UNITED STATES PATENT AND TRADEMARK OFFICE

APPLICATION NO.	FILING DATE	FIRST NAMED INVENTOR	ATTORNEY DOCKET NO.	CONFIRMATION NO.
09/964,204	09/26/2001	Vinod Nair Gopikuttan Nair	2000 P 16657 US	1833

Office Action Summary

DETAILED ACTION

FIG. 1

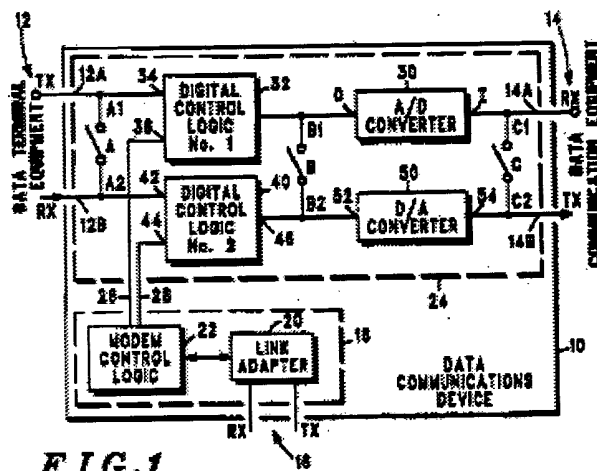
With respect to claim 1, Ray, Jr. et al ('435) anticipate a communication circuit arrangement (see Fig 1, 24) below with directional signal paths comprising:

a first signal path (14A, 30, B1, 32, 12A) to transmit a first signal into a first direction (see col. 3 lines 59-66), having an input terminal (14A) and an output terminal (12A) and including a first digital circuit block (32) (see col. 3, lines 63-64) to process the first signal.

a second signal path (12B, 40, B2, 50, 14B) to transmit a second signal into a second direction (see col. 4, lines 6-33) having an input terminal (12B) and an output terminal (14B) and including a first digital circuit block (40) (see col. 4, lines 17-18) to process the second signal and

a first switch (B) having a first terminal coupled to a first circuit node (B1) within the first signal path (14A, 30, B1, 32, 12A) and a second terminal coupled to a second circuit node (B2) within the second signal path (12B, 40, B2, 50, 14B) to provide a test signal loop (see col. 5, lines 66-68 and col. 6, lines 1-5) during a test mode of the circuit arrangement.

With respect to claim 2, Ray, Jr. et al ('435) teach that their first signal path (14A, 30, B1, 32, 12A) comprises a first analog circuit block (30) coupled between the first digital circuit block (32) and the output terminal of the first signal path (14A)

Ray, Jr. et al ('435) also teach that their second signal path (12B, 40, B2, 50, 14B) comprises a second analog circuit block (50) coupled between the second digital circuit block (40) and the input terminal of the second signal path (14B).
